Project Name | BCWD Permit 26-03 7 Brew Coffee**Date** | 6/4/2026**To / Contact info** | BCWD Board of Managers**Cc / Contact info** | Toth Associates / Brian Van Rooyen, PE**Cc / Contact info** | Karen Kill, Administrator / BCWD**From / Contact info** | Camilla Correll, PE; Julia Lau, EIT / EOR**Regarding** | Permit Application No. 26-03 Engineer's Report

Applicant: Quattro Oak Park LLC**Complete Permit Submittal Date:** 5/13/2026**Board Action Required By:** 7/11/2026**Review based on BCWD Rules effective April 1, 2020****Recommendation:** Approve with Conditions

Figure 1: Site Plan

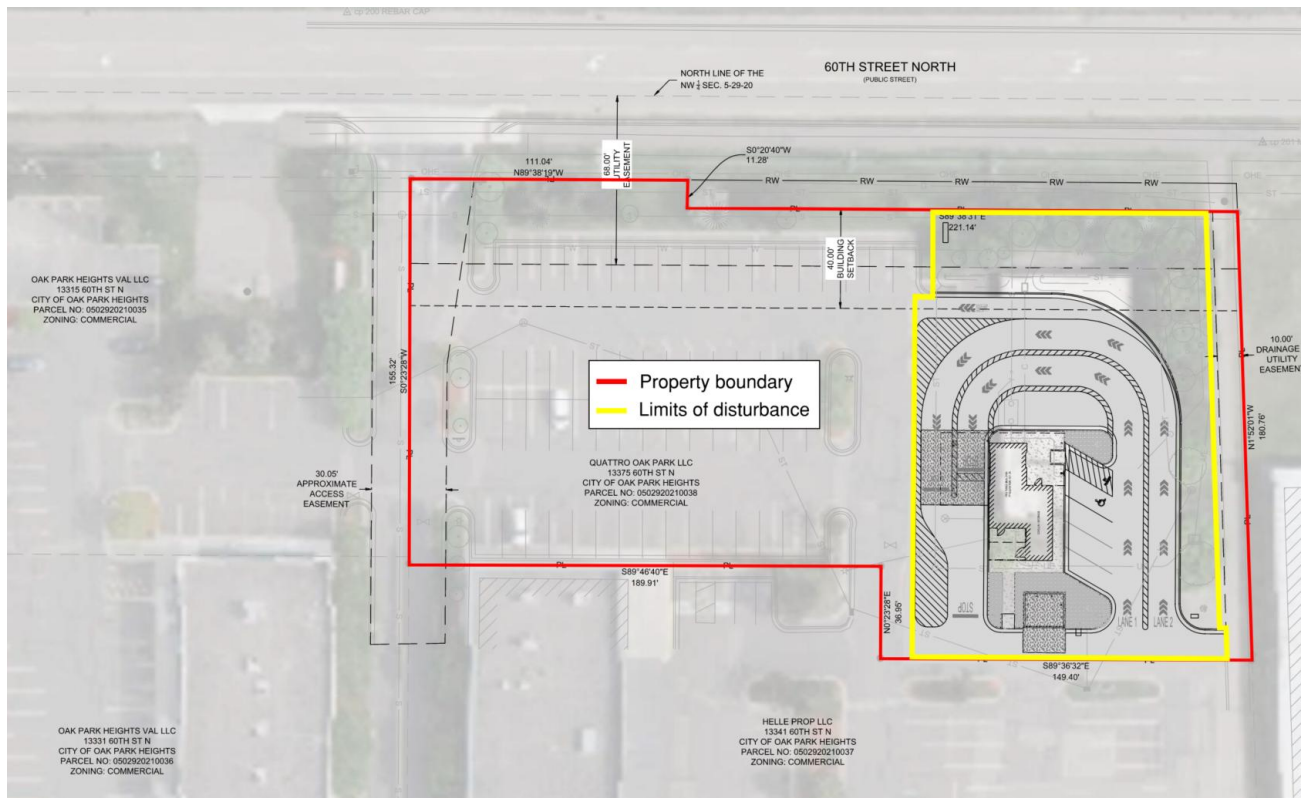
Proposed Conditions: The applicant proposes to demolish the Ruby Tuesday building, reconfigure the east side of the parking lot, and construct a new 7 Brew Coffee building (Figure 1). Additional storm sewer and an iron-enhanced biofiltration basin will be connected to the existing storm sewer system. The general flow pattern will remain from east to west, discharging into the existing pond on the adjacent site to the west. The project will disturb 0.44 acres of the site, including 0.343 acres of existing impervious surface. The total proposed final impervious area on the parcel will be 0.982 acres (78% of the total site), which is a reduction of 0.003 acres of impervious area from existing conditions.
